Product Change Notification

Topic:	Product Change Notification (PCN)
Author:	Product Manager
Date:	March 2025

CA-MP-MTI-12	CA-USB-CONV

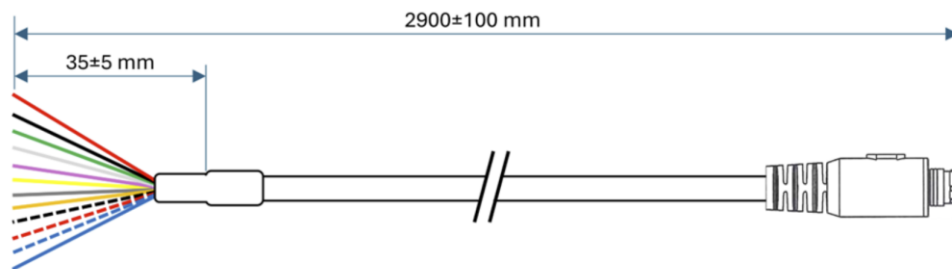
CA-MP-12-OPEN is a 12-pin Host Interface cable assembly with open ends and consists of the following parts:

- ODU connector: A10WAM-P12XMM0-0000; AMC HD, break-away plug, 12 circuits.
- Cable: 2.9m length, 12 core, AWG28, shielded, UL, 40°C ± 85°C, 6.1mm diameter.

The table below shows the pinning of the connectors. The shield of the cable is only connected on the ODU connector side.

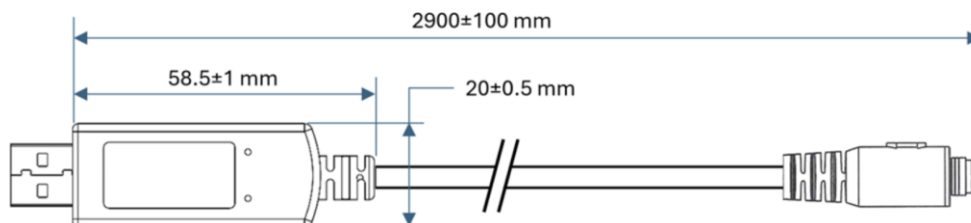
CA-MP-USB is a RS232 to USB cable that has the USB converter integrated at the end of the cable and consists of the following parts:

- ODU connector: A10WAM-P12XMM0-0000; AMC HD, break-away plug, 12 circuits.
- Cable: 2.9m length, 12 core, AWG28, shielded, UL, 40°C ± 85°C, 5.1mm diameter.
- USB converter.

The table below shows the pinning of the connectors:
